**DESIGN BUILD CONSTRUCTION SERVICES FOR THE LANEY COLLEGE CENTRAL UTILITY
PLANTS UPGRADE PROJECT**

RFP No. 19-20/12

ADDENDUM No. 2

RFI LOG - LANEY CUP RFP

SITE PLAN -
ELECTRIC DISTRIBUTION

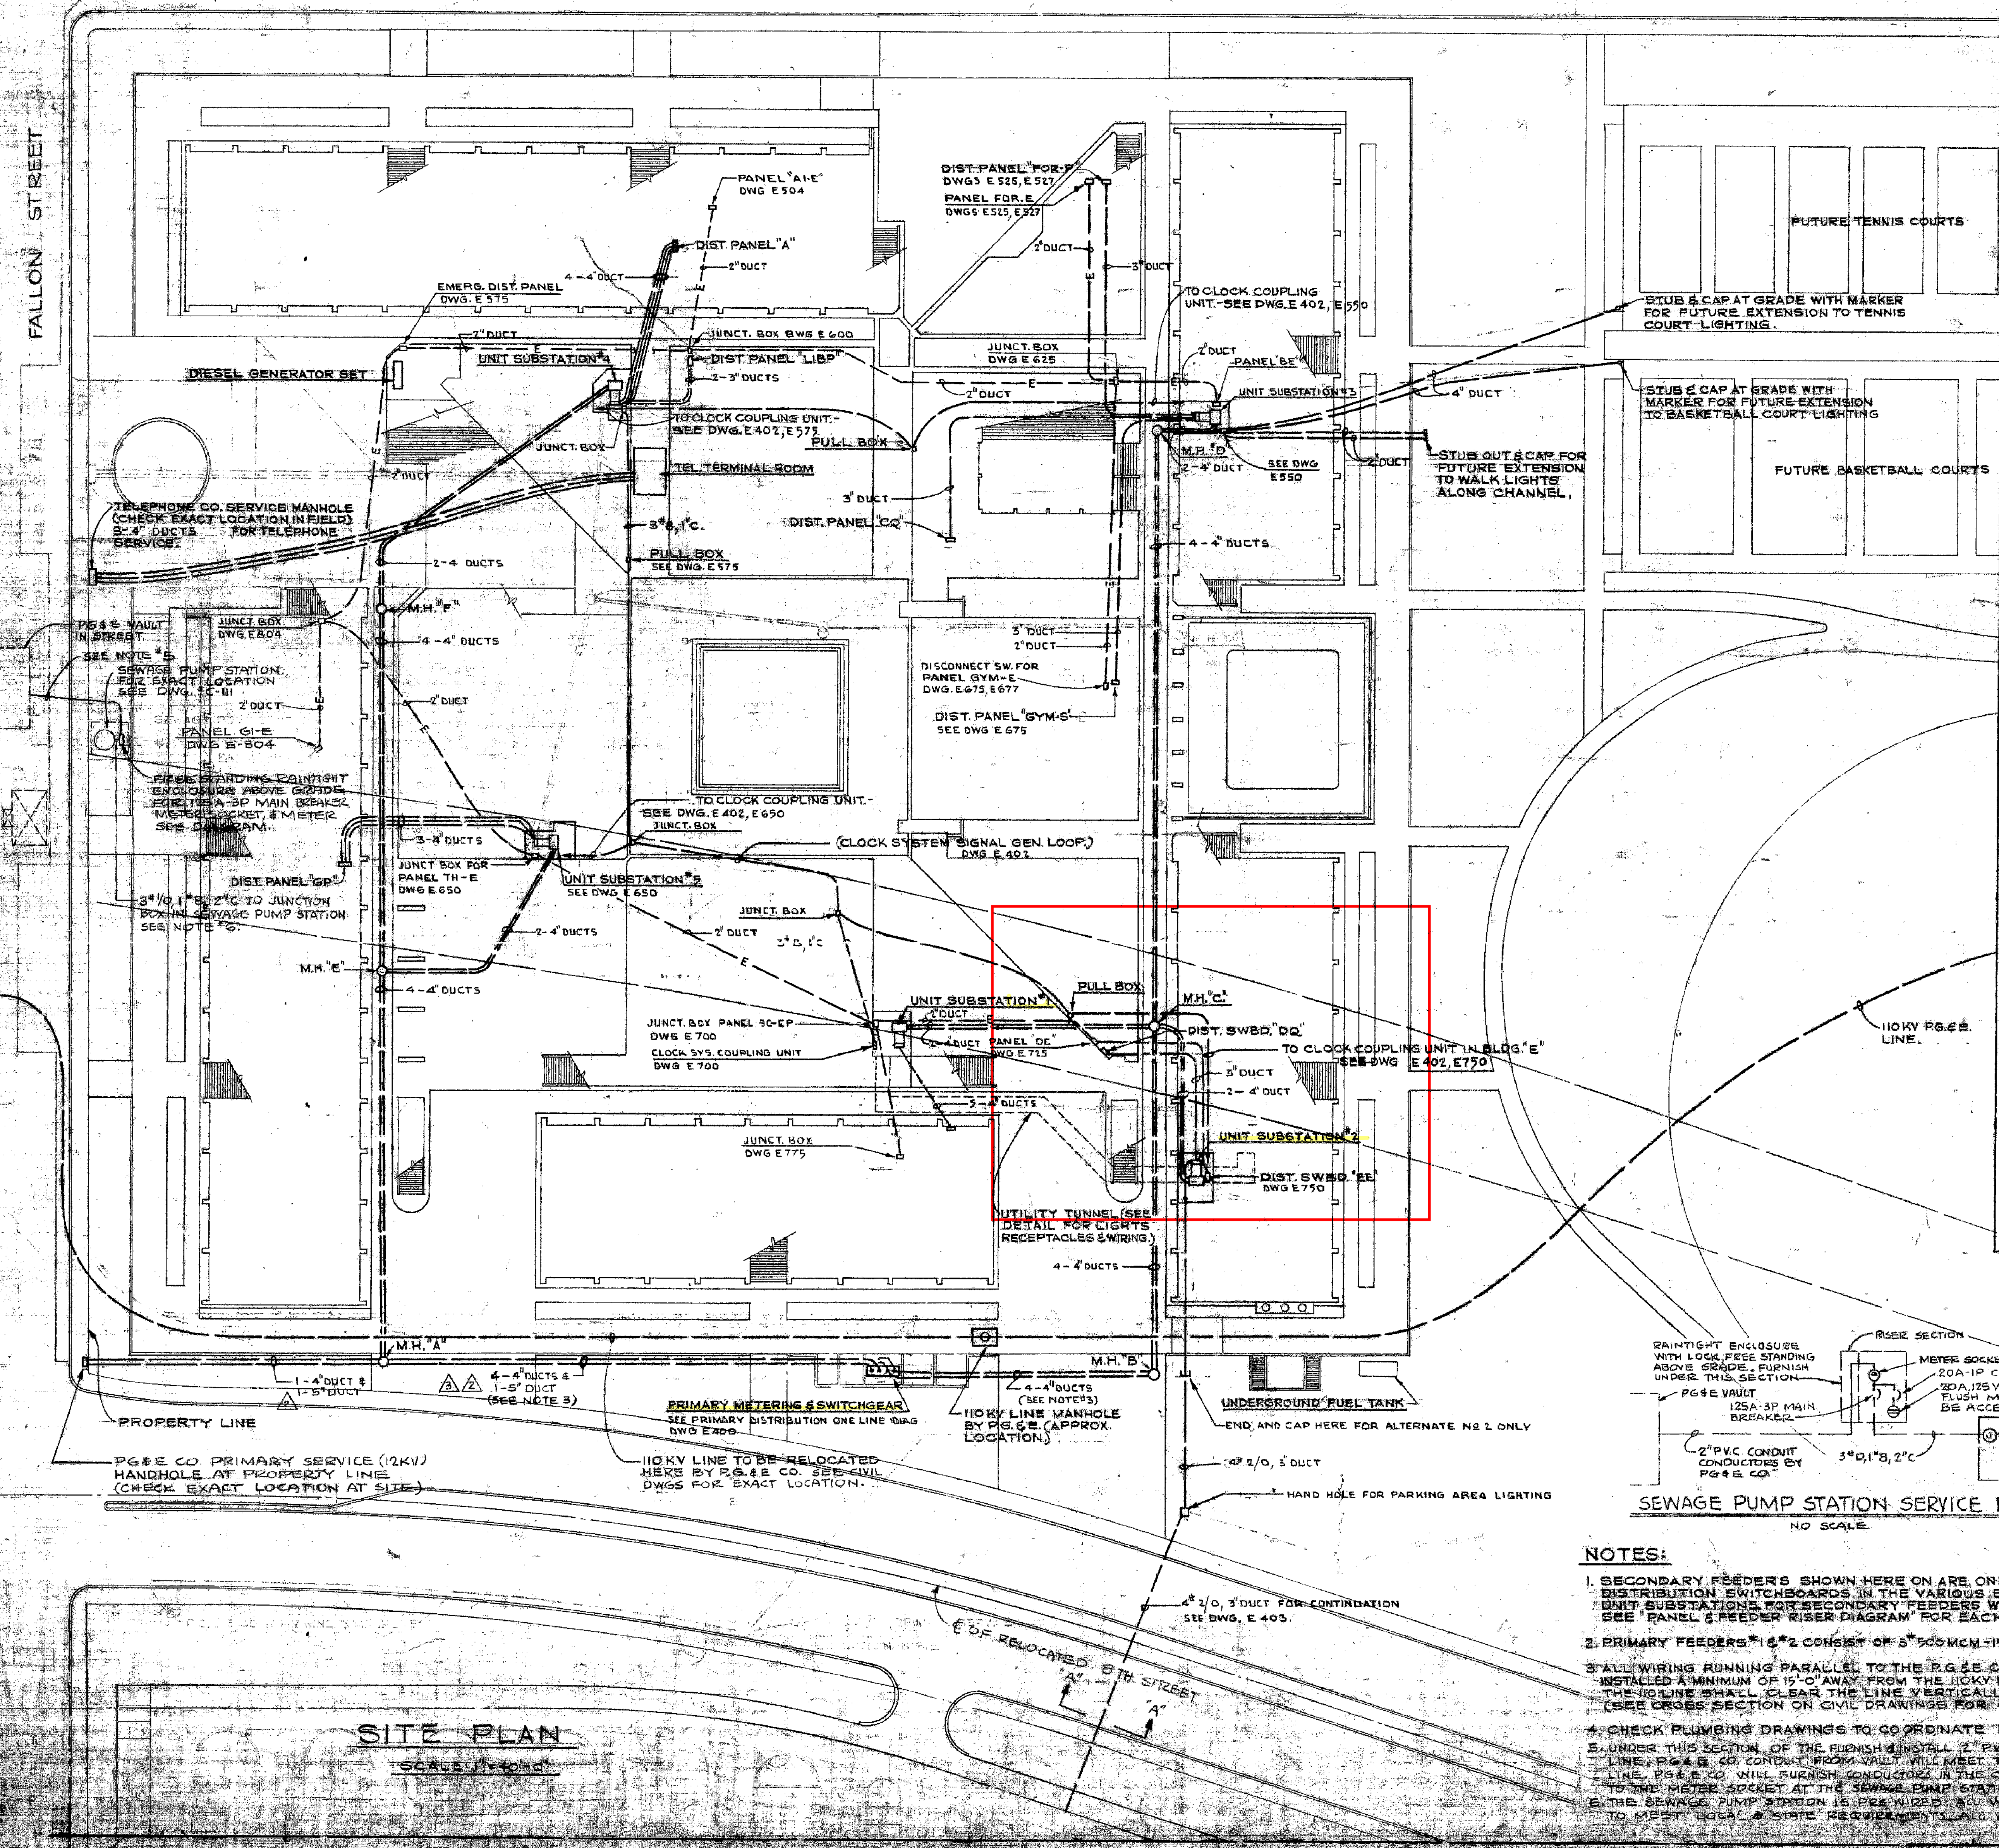
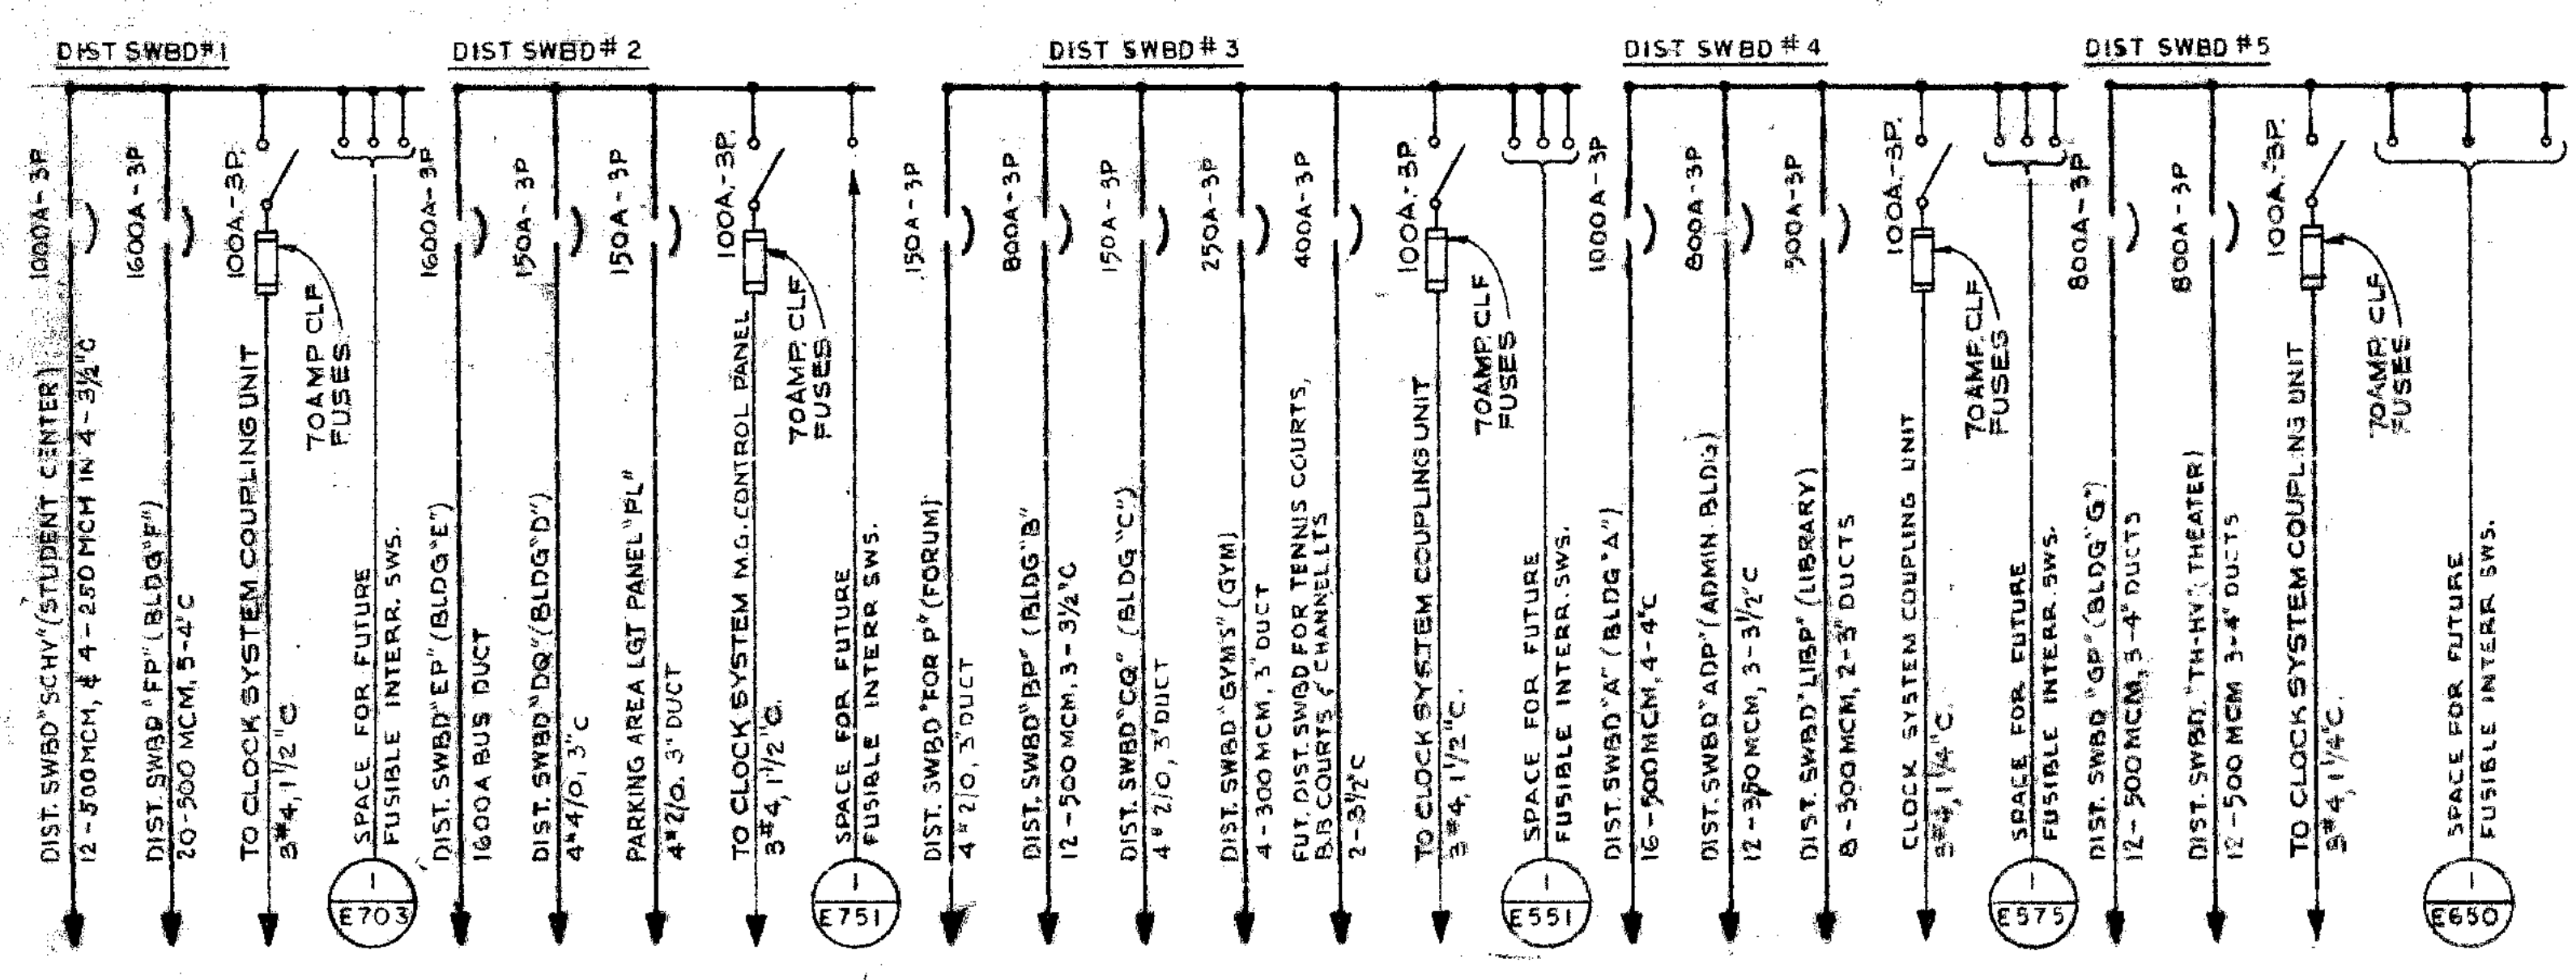
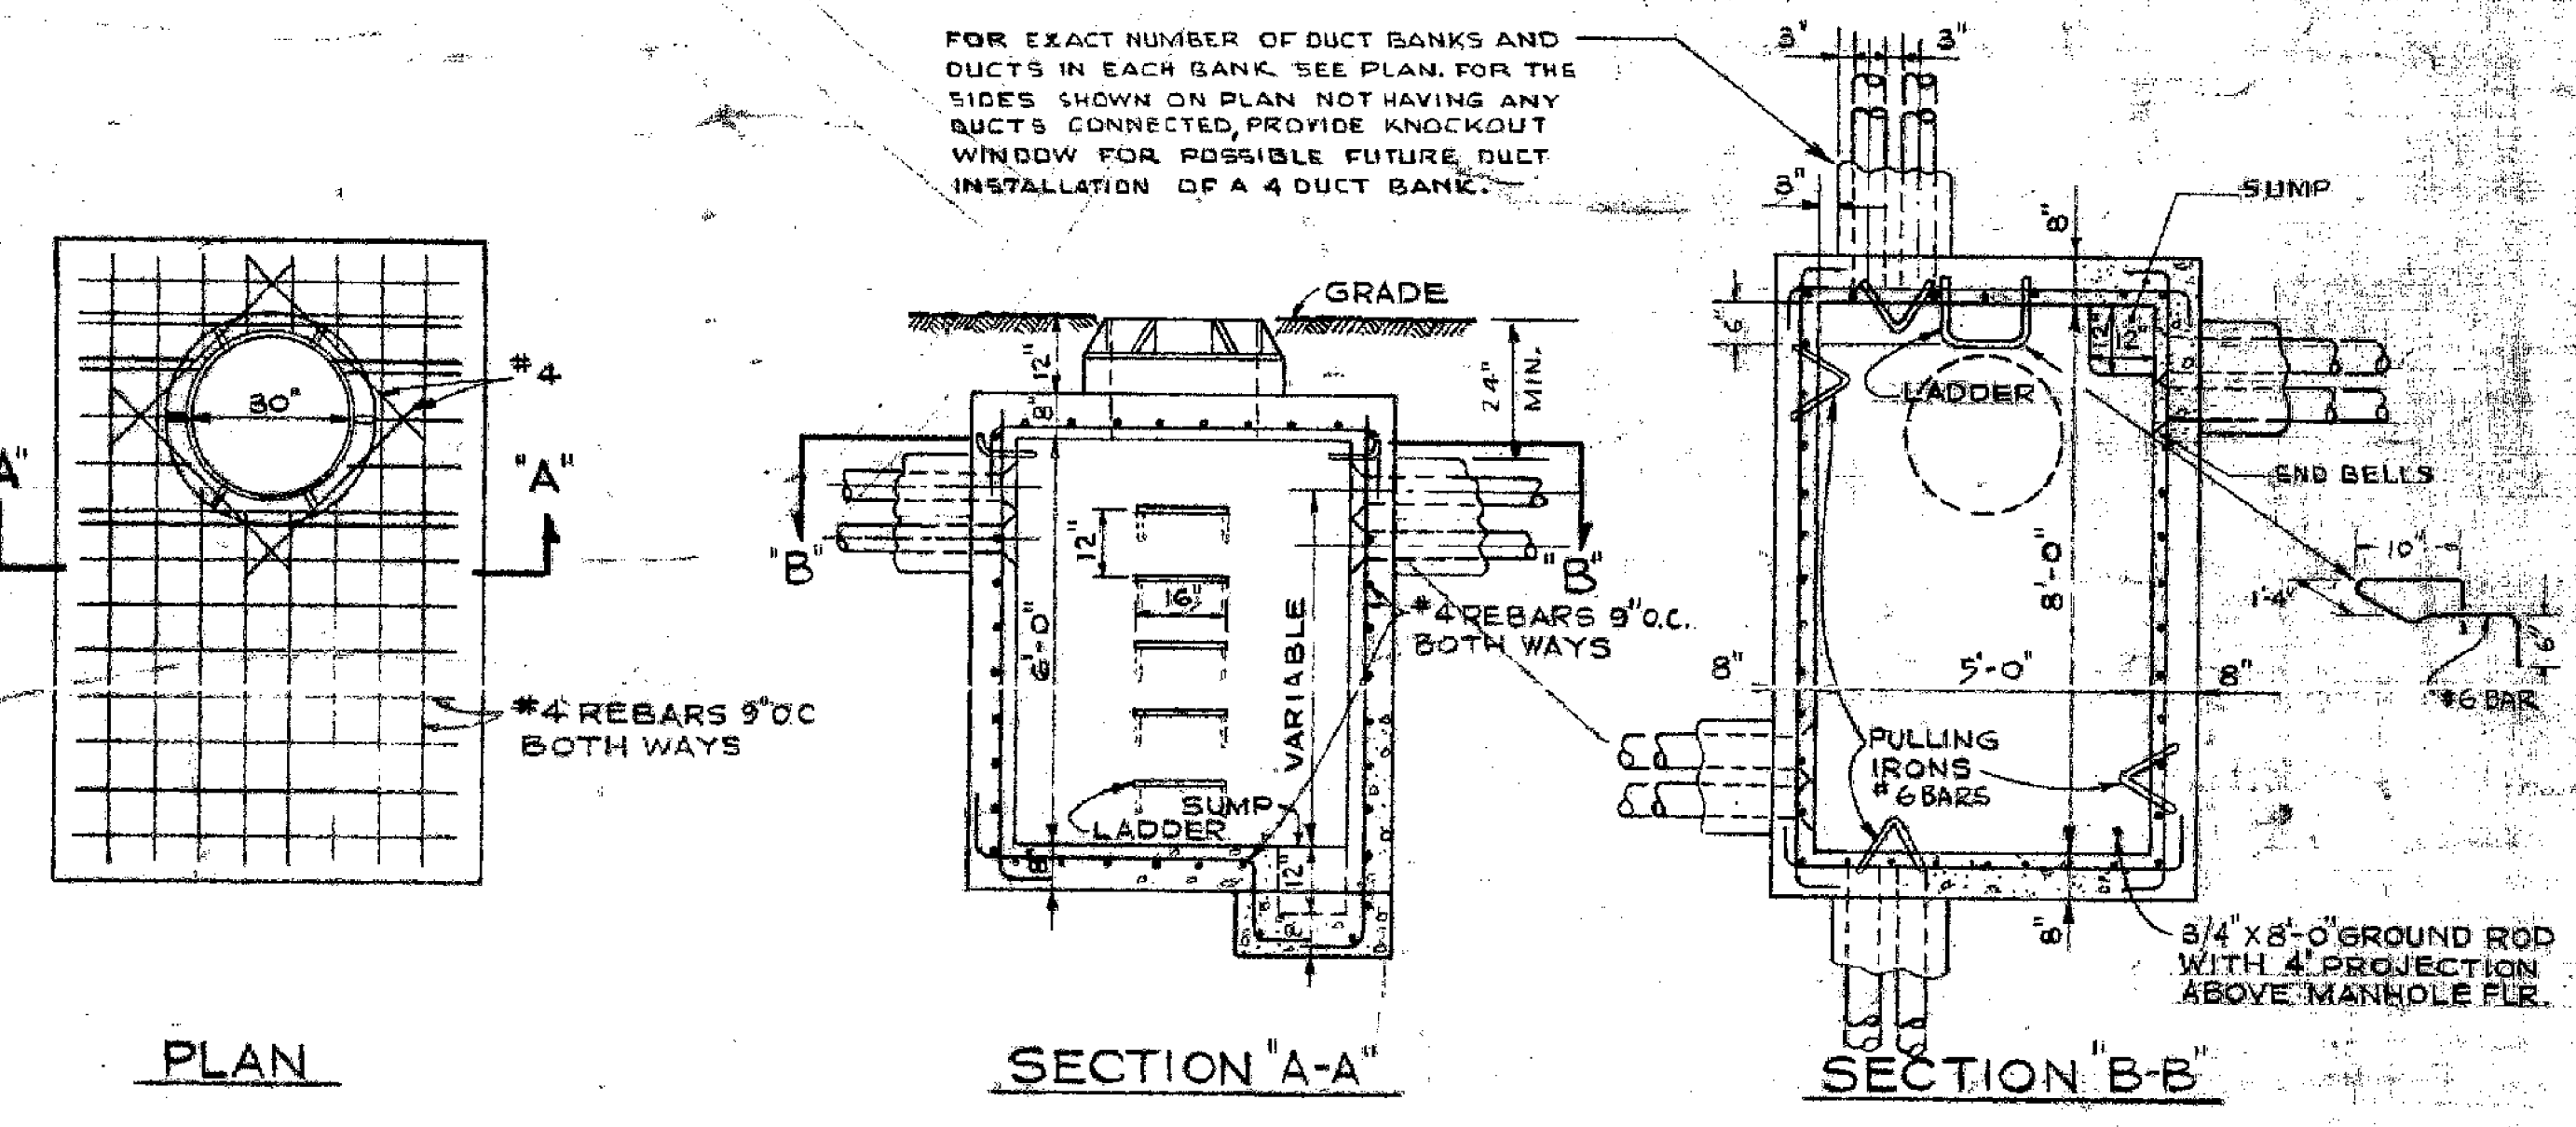
P008		Sheet C4.00 notes the relocation of a 12kv duct bank between manhole A and the existing switchgear. Is there a single line diagram or other information available to explain what this branch serves and the associated shut down required?	Refer attached plans "P008 1968 Laney Set Showing MH".	2
P009		Can the district provide the LRC building plans for reference?	Issued with Addendum No.01	2
P010		The criteria documents call for the relocation of the domestic water backflow preventor. Has there been any correspondence with EBMUD regarding the proposed location?	The criteria documents call for new domestic backflow preventor. The location was not coordinated with EBMUD staff.	2
P011		What is the timing of the relocation of the 36-inch EBMUD watermain shown on sheet C4.01? Will it be relocated prior to the construction of this project? If not what are the criteria/requirements for construction within the easement and for crossing the water main?	The EBMUD water main relocation is forecast to occur in 16 to 25 months. If the water main relocation is not completed, then design criteria will be provided from the EBMUD plans and specifications.	2
